**REPLACES:** Please discard MC 06-07 dated June 27, 2006**MODEL:** 2004-2005 VULCAN® 2000 (VN2000-A1/L-A2/L)**TITLE:** ENGINE PULLEY WEAR

## FACTORY DIRECTED MODIFICATION

On eligible units, the splines on the engine pulley and/or pulley shaft may be worn due to the type of assembly lubricant used during assembly. This can result in the engine pulley mounting nut not applying enough clamping force to properly hold the pulley in place and creating abnormal wear on the splines of the pulley and/or pulley shaft. The worn splines may cause abnormal noise and the vehicle may not accelerate smoothly.

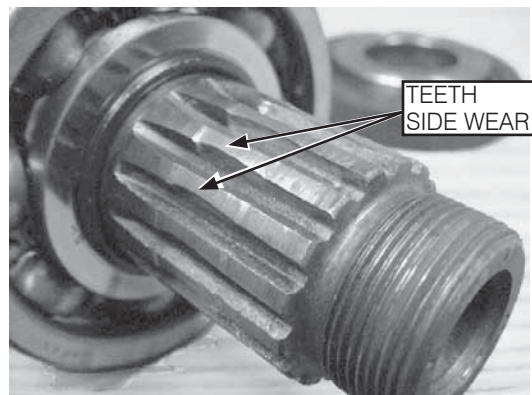
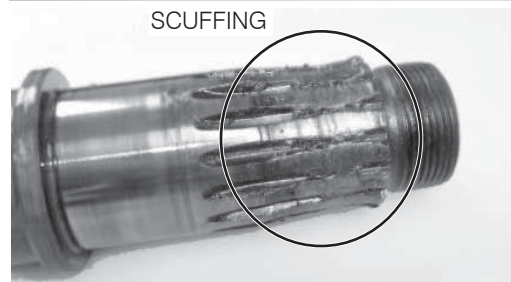
- Remove the engine pulley from the pulley shaft and inspect the splines on the pulley and shaft to determine if they are worn.

GOOD PULLEY

WORN PULLEY

- ★ If the pulley and shaft are not worn, follow the instructions in Installation of Engine Pulley.
- ★ If only the engine pulley splines are worn, replace the pulley following the instructions in Installation of Engine Pulley.
- ★ If the pulley shaft is also worn, replace it following the instructions in Replacement of the Pulley Shaft.

### Installation of the Engine Pulley

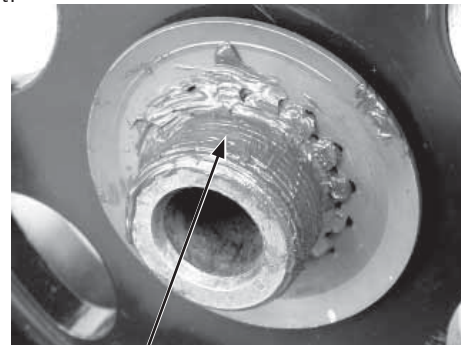
- Align the splines inside the engine pulley with those on the pulley shaft and mount the pulley.
- Replace the pulley washer with a new one.
- Apply molybdenum grease to the threads of the pulley shaft and seating surface of the engine pulley mounting nut, then tighten the nut.

APPLY  
MOLYBDENUM  
GREASE

Torque – Engine Pulley Mounting Nut: 130 ft.-lb. (177 N-m, 18 kgf-m)

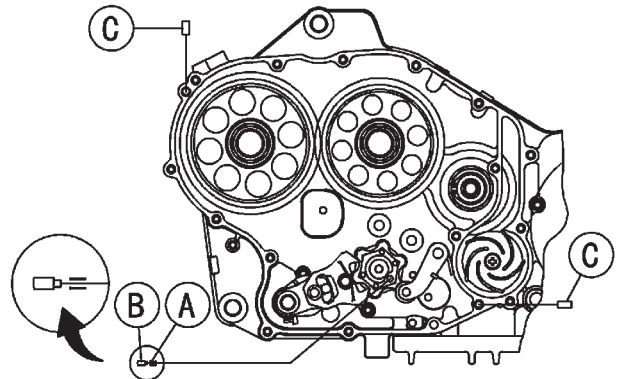
- Install the pulley shaft bearing retainers and screws.

Torque – Bearing retainer screws: 61 in.-lb. (6.9 N-m, 0.7 kgf-m)
